SAFETY BULLETIN

Communication #: T-19-02

Model Year(s): 2019

SUBJECT: 10A CIRCUIT BREAKER REPLACEMENT PURPOSE

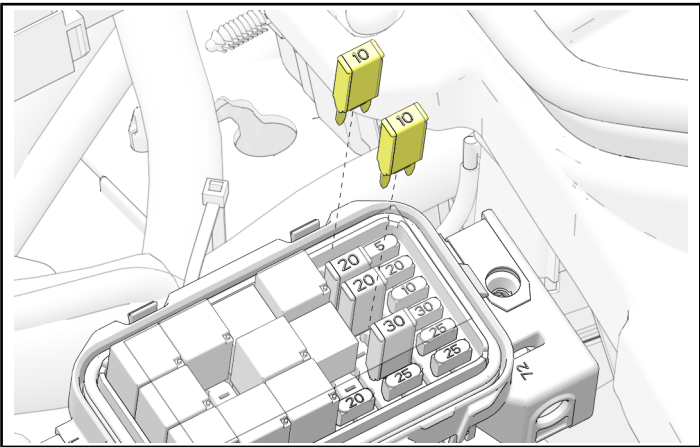
4. Identify the two 10A breakers ② (marked ECM 10A BRKR and IGNITION 10A BRKR in the fusebox cover legend).

5. Remove two 10A breakers and discard.

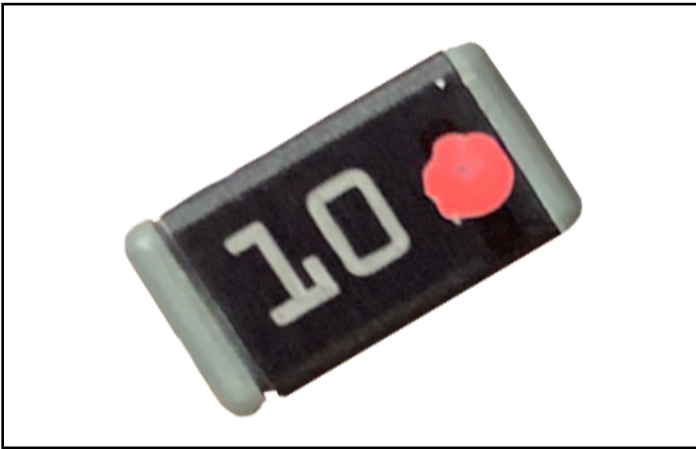
6. Verify replacement breaker has red paint dot on it.

7. Install two replacement 10A breakers.
